CITY OF VINCENT

## DESIGN ADVISORY COMMITTEE

### MINUTES

**Address:** Nos. 61-73 (Lot 9) Cleaver Street, West Perth

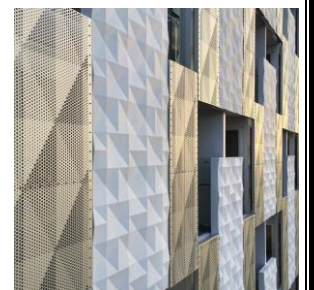
The building's elevations appear expansive. They include large areas of repetitive 'punctured' openings that create an institutional aesthetic, which is not supported.

The elevation drawings and design need further development. Articulation of elements, more relief, perhaps staggered windows, or some other regimen needs to be applied to remove the monotony.

The building would benefit from more detailed design treatments associated with private rooms and fenestration details. The idea of 'the inhabited façade' and how this might be expressed (not just punched windows in precast concrete) will help give the large scale facades a finer grain quality and more 'inhabited' quality.
